TRANS/WP.29/GRE/2005/44
25 July 2005

PROPOSAL FOR DRAFT 03 SERIES OF AMENDMENTS TO REGULATION No. 48

(Installation of lighting and light-signalling devices)

Transmitted by the Chairman of the Conspicuity Marking Informal Working Group

Model A

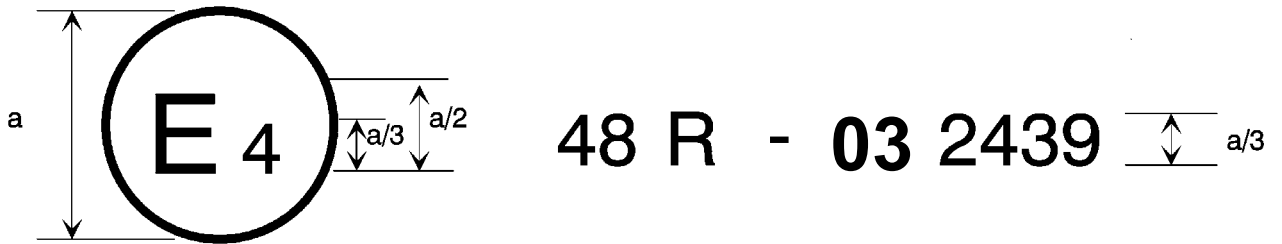
The above approval mark affixed to a vehicle shows that the vehicle type concerned has, with regard to the installation of lighting and light-signalling devices, been approved in the Netherlands (E4) pursuant to Regulation No. 48 as amended by the **03** series of amendments. The approval number indicates that the approval was granted in accordance with the requirements of Regulation No. 48 as amended by the **03** series of amendments.

Model B

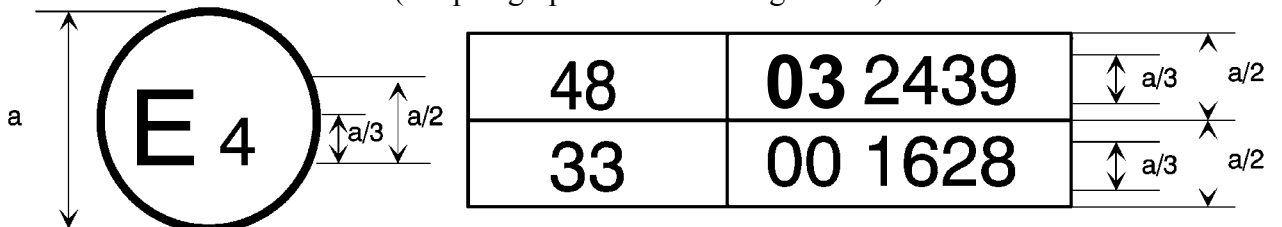
The above approval mark affixed to a vehicle shows that the vehicle type concerned has been approved in the Netherlands (E4) pursuant to Regulation No. 48 as amended by the **03** series of amendments and Regulation No. 33. 1/ The approval number indicates that, at the dates when the respective approvals were given, Regulation No. 48 was amended by the **03** series of amendments and Regulation No. 33 was still in its original form."

"Annex 11

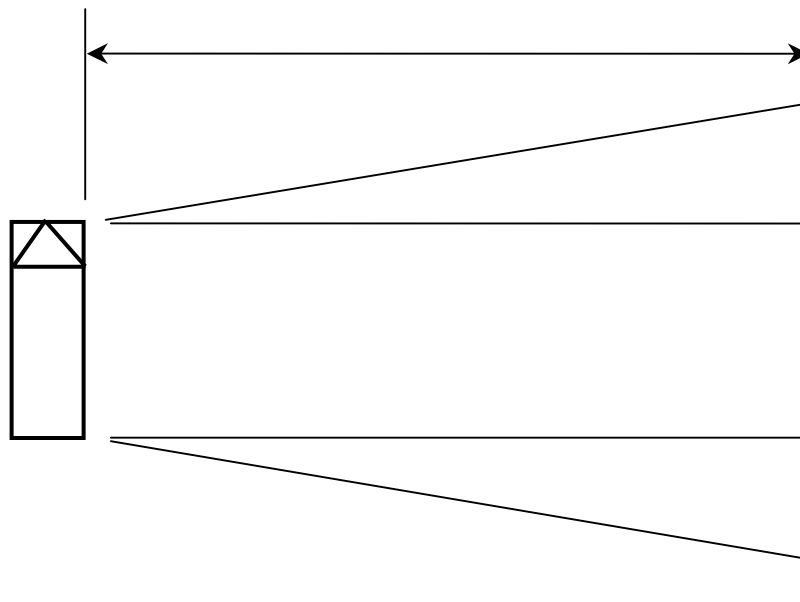
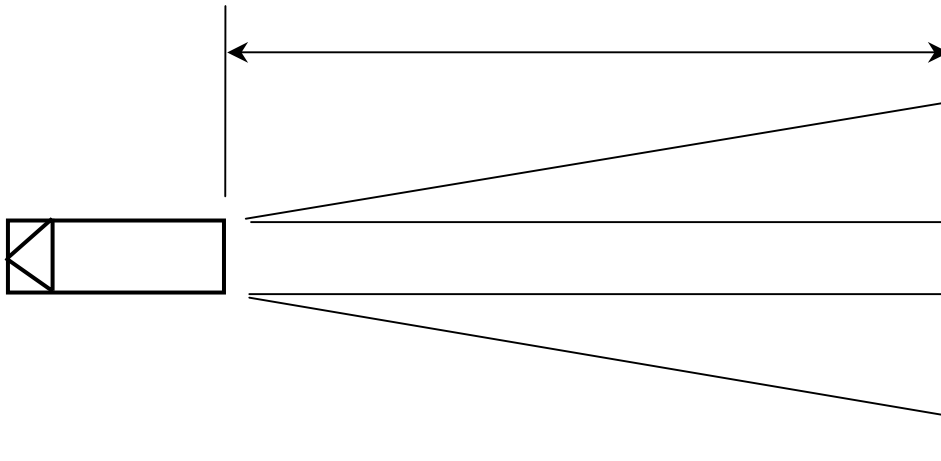
**VISIBILITY OF CONSPICUITY MARKINGS TO THE REAR AND
SIDE OF A VEHICLE**

(see paragraph 6.21.5. of this Regulation)

6.21.5. – Provisions needed to be defined for determining the "visibility" of the markings. It was acknowledged that the normal geometric visibility provisions could not be applied, therefore the same principle has been applied for the visibility of white/red light to the rear/front. It is intended that compliance with the requirement can be demonstrated graphically, or by calculation. This is not a measure of the photometric performance of the markings and, therefore, should not be required to be conducted under darkened conditions with the surfaces being illuminated. A new Annex 11 has been drafted to aid the comprehension of the observation plane.

- 6.21.5.1.** for rear conspicuity markings (see Annex 11, Figure 1) the observation plane is perpendicular to the longitudinal axis of the vehicle situated 25 m from the extreme end of the vehicle and bounded by:

6.21.5.2. for side conspicuity markings (see Annex 11, Figure 2) the observation plane is parallel to the longitudinal median plane of the vehicles situated 25 m from the extreme outer edge of the vehicle and bounded by:
